## HISTORIC AND DESIGN REVIEW COMMISSION

**HDRC CASE NO:** 2024-427  
**ADDRESS:** 214 ADAMS ST  
**LEGAL DESCRIPTION:** NCB 943 BLK 1 LOT 12  
**ZONING:** RM-4, H  
**CITY COUNCIL DIST.:** 1  
**DISTRICT:** King William Historic District  
**APPLICANT:** Jaime Jimenez/Idea Studio  
**OWNER:** Maher Saloum/SALOUM MAHER  
**TYPE OF WORK:** Conceptual review of a 2-story rear addition and 2-story rear accessory structure construction  
**APPLICATION RECEIVED:** December 18, 2024  
**60-DAY REVIEW:** February 16, 2025  
**CASE MANAGER:** Bryan Morales

### REQUEST:

A2.0

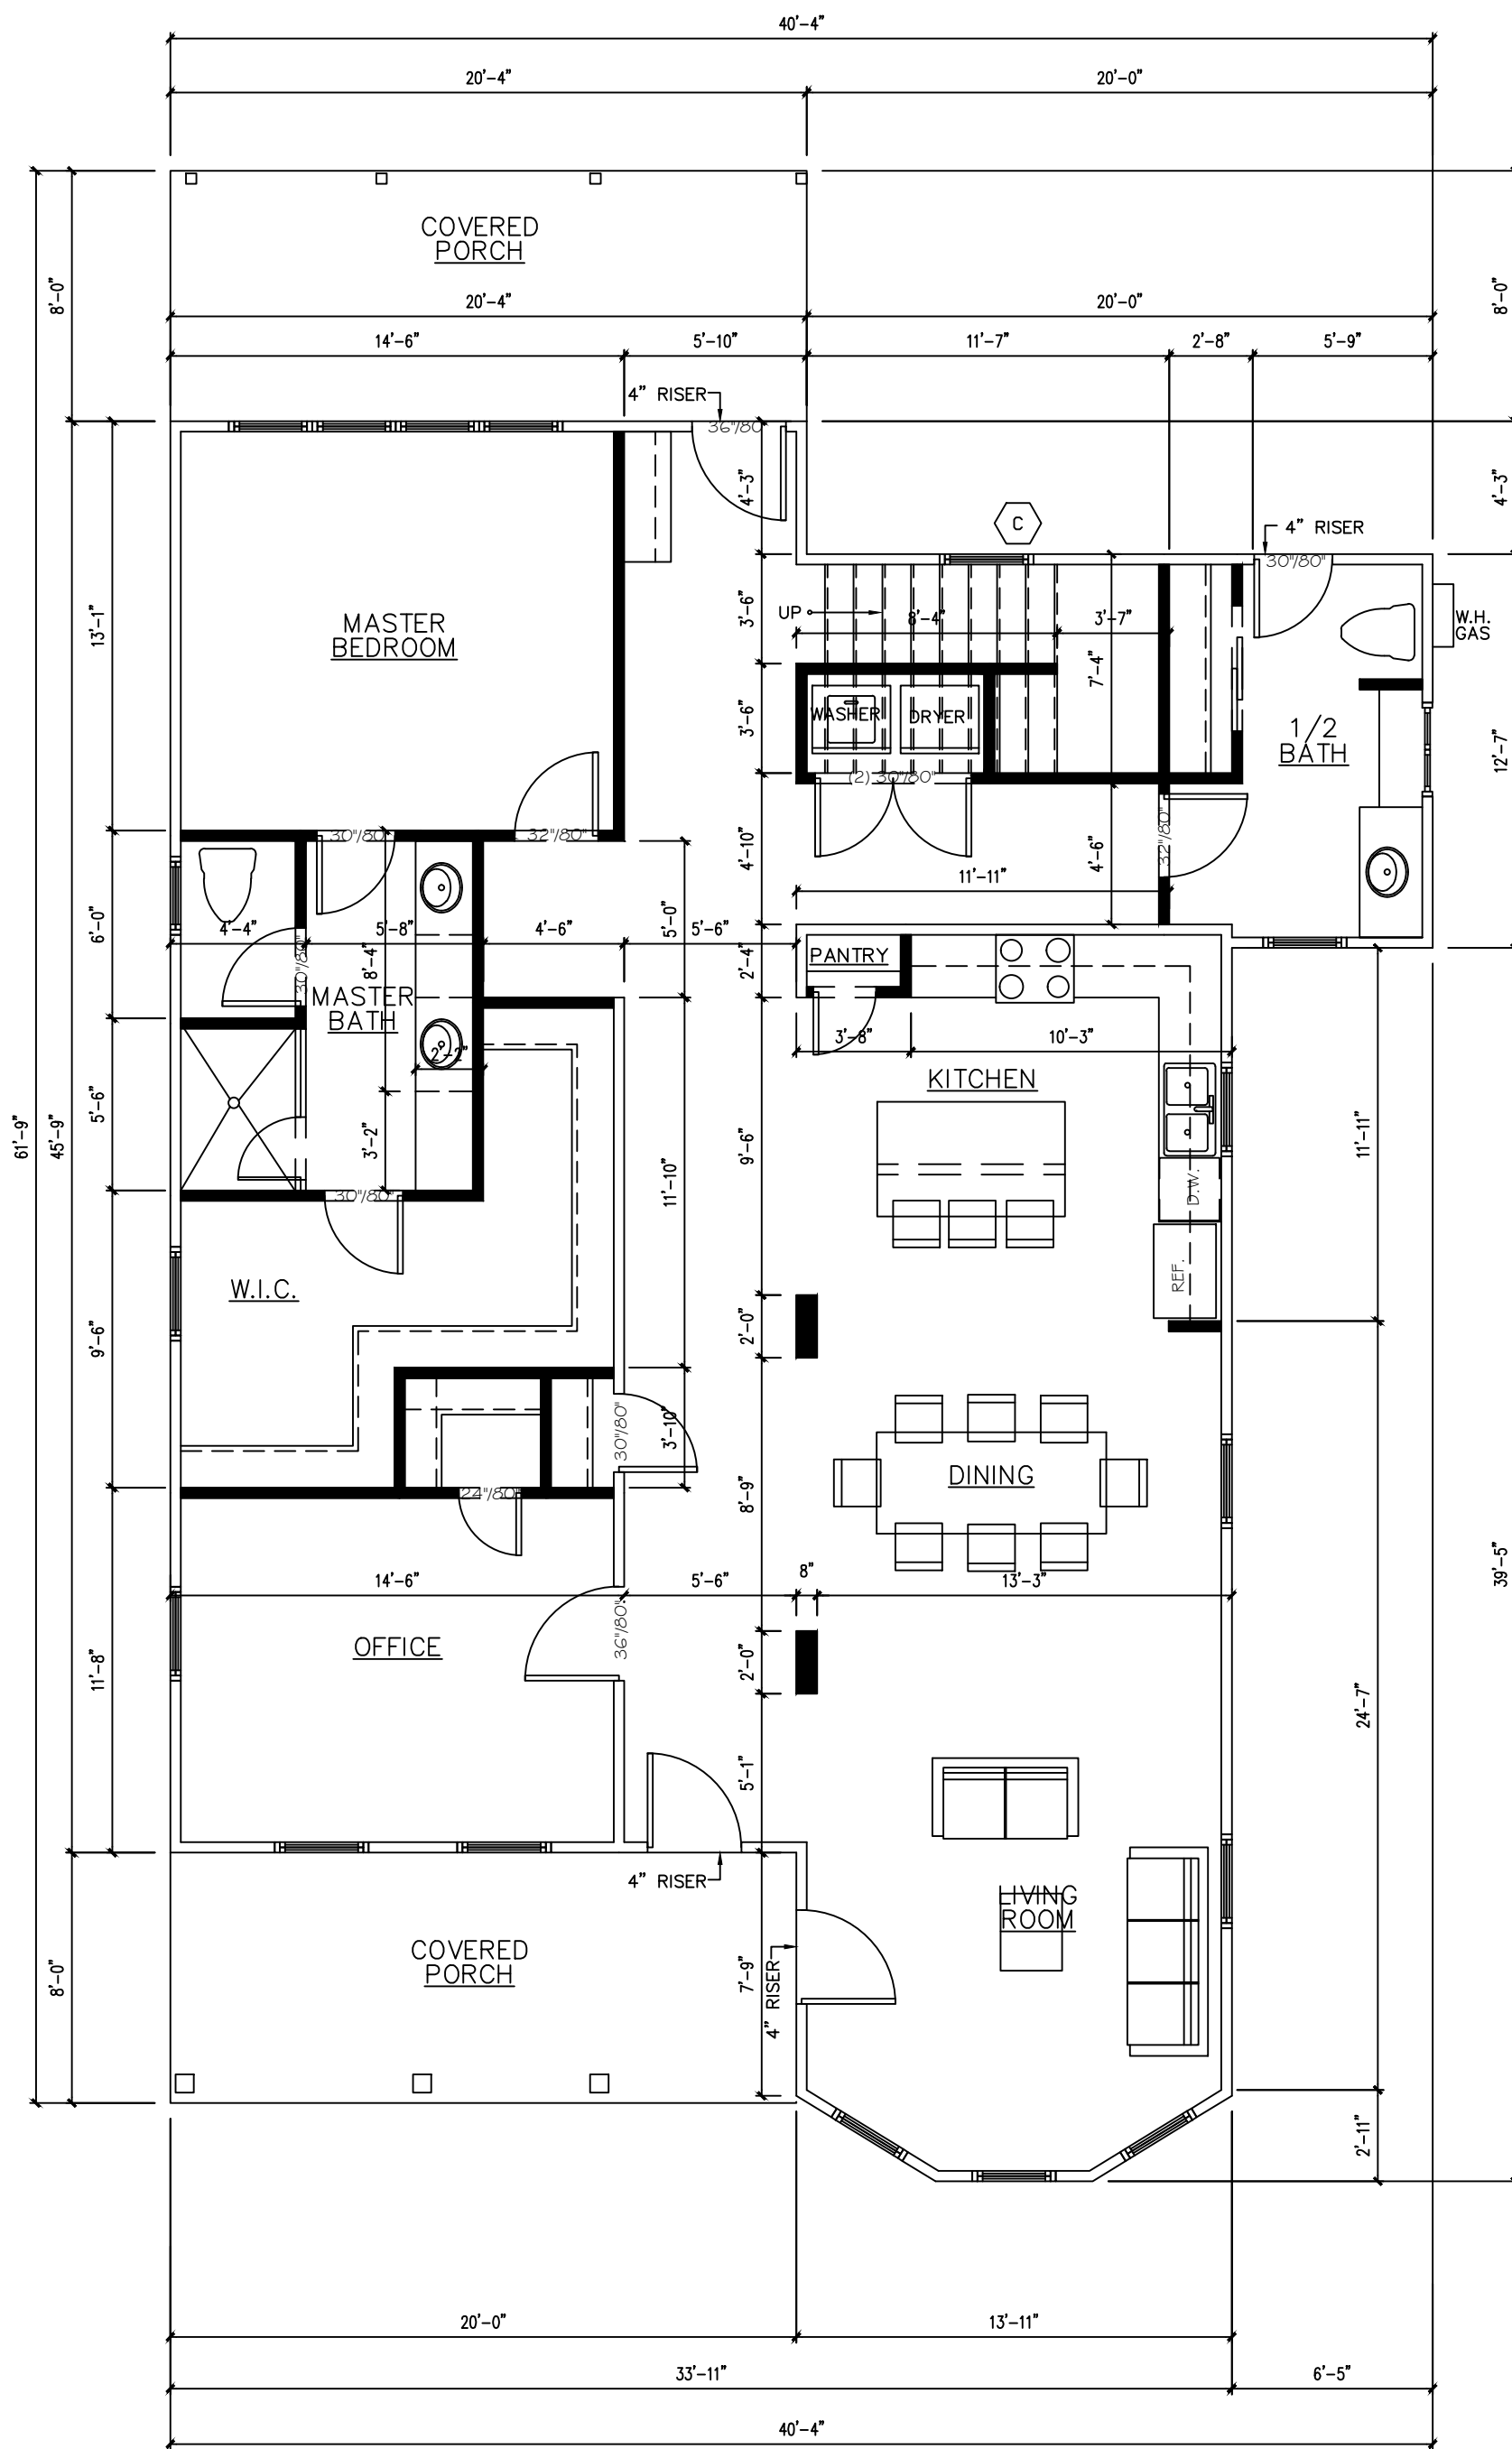
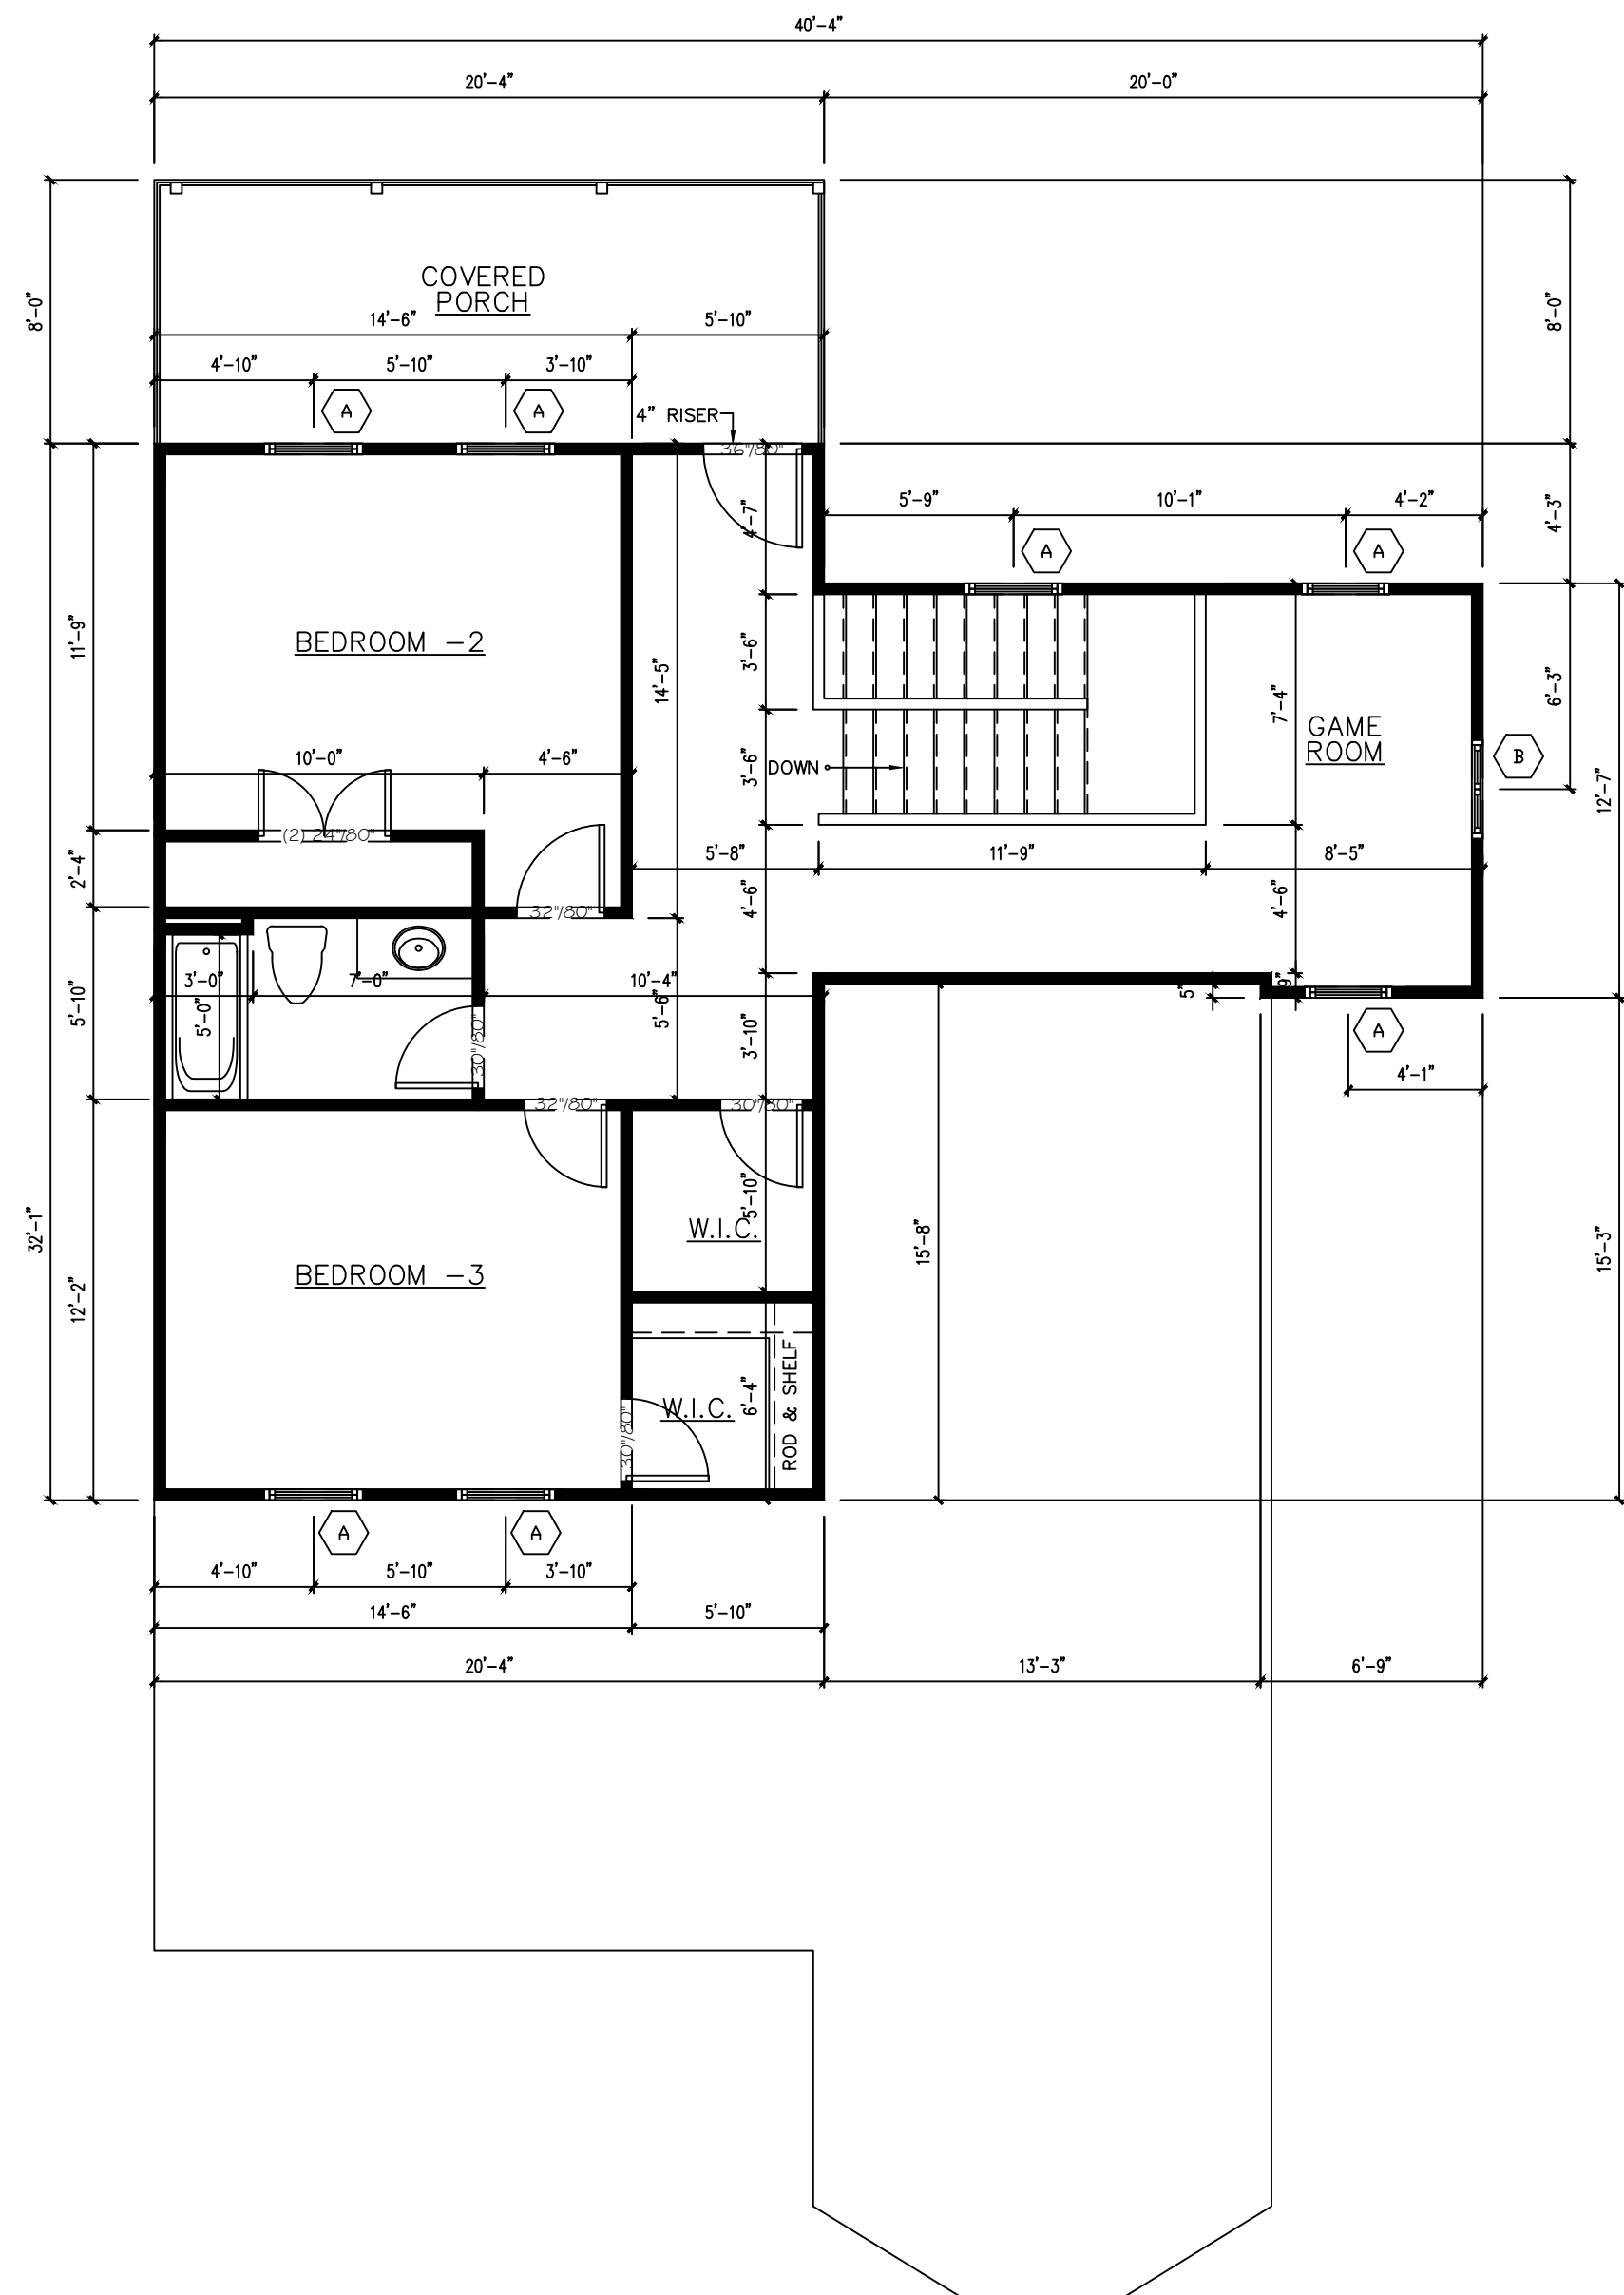
- e. TWO-STORY REAR ADDITION (MASSING & FOOTPRINT) – The applicant is requesting conceptual approval to construct a 2-story rear addition. The existing primary structure is a 1-story structure. Additions 1.B.i stipulates

residential additions should be designed to be subordinate to the principal façade of the original structure in terms of scale and mass. Additions 2.B.iv states the building footprint should respond to the size of the lot. An appropriate yard to building ratio should be maintained for consistency within historic districts. Residential additions should not be so large as to double the existing building footprint, regardless of lot size. Staff finds the proposal does not conform to Guidelines.

- k. REAR ADDITION (NEW WINDOWS & DOORS: SIZE AND PROPORTION) – The applicant is requesting conceptual approval to install three one-over-one windows on the front elevation, four one-over-one windows and a door on the rear elevation, and one sliding window on the left elevation. The Standard Specifications for Windows in Additions and New Construction clarifies that new windows on additions should relate to the windows of the primary historic structure in terms of materiality and overall appearance. In addition, whole window systems should match the size of historic windows on the property unless otherwise approved and windows should feature traditional dimensions and proportions as found within the district. Staff finds the installation of the proposed rear door generally appropriate. Staff finds the proposed one-over-one windows generally appropriate. Staff finds the proposed sliding window does not conform to Guidelines. Window and door specifications are required for review prior to the issuance of a Certificate of Appropriateness and will be required for final review.

- l. REAR ADDITION (RELATIONSHIP OF SOLIDS AND VOIDS) – According to the Historic Design Guidelines, new construction should incorporate window and door openings with a similar proportion of wall to window space as typical with nearby historic facades. Windows, doors, porches, entryways, dormers, bays, and pediments shall be considered similar if they are no larger than 25% in size and vary no more than 10% in height to width ratio from adjacent historic facades. Avoid blank walls, particularly on elevations visible from the street. No new façade should exceed 40 linear feet without being penetrated by windows, entryways, or other defined bays. Staff finds the proposed fenestration pattern on the second story generally appropriate; however, the applicant should incorporate additional one-over-one window openings on the right elevation that relate to existing fenestration pattern found on the historic footprint.

- m. REAR ADDITION (BALCONY) – The applicant is requesting conceptual approval to construct a balcony attached to the proposed second story addition’s rear elevation measuring approximately 160 sqft. Additions 1.B.i stipulates residential additions should be designed to be subordinate to the principal façade of the original structure in terms of scale and mass. Additions 1.B.v. states that generally, the height of new additions should be consistent with the height of the existing structure, the maximum height of new additions should be determined by examining the line-of-sight or visibility from the street, and the addition height should never be so contrasting as to overwhelm or distract from the existing structure. Staff finds the construction of a second story balcony does not conform to Guidelines.

- n. FENESTRATION MODIFICATIONS (REAR) – The applicant is requesting conceptual approval to replace an existing rear-facing window with a door. The applicant has not provided door specifications for review. Exterior Maintenance and Alterations 6.A.i. states to preserve existing window openings. Exterior Maintenance and Alterations 6.A.iii. states to preserve historic windows. Staff finds the replacement of the rear-facing window with a door generally appropriate; however, the window should be reused onsite and door specifications should be provided to staff for review prior to the issuance of a Certificate of Appropriateness and will be required for final review.

- o. FENESTRATION MODIFICATIONS (LEFT) – The applicant is requesting conceptual approval to replace three windows with one sliding window on the left façade. The applicant has not provided window specifications for review. Exterior Maintenance and Alterations 6.A.i. states to preserve existing window openings. Exterior Maintenance and Alterations 6.A.iii. states to preserve historic windows. Staff finds the replacement of the left-facing windows with one window does not conform to Guidelines.

Item 1: Staff does not recommend conceptual approval of the 2-story rear addition construction based on the findings. Staff recommends the applicant reduce the height of the proposed rear addition to 1-story and incorporate staff’s suggestions noted in findings a through p before returning for final review.
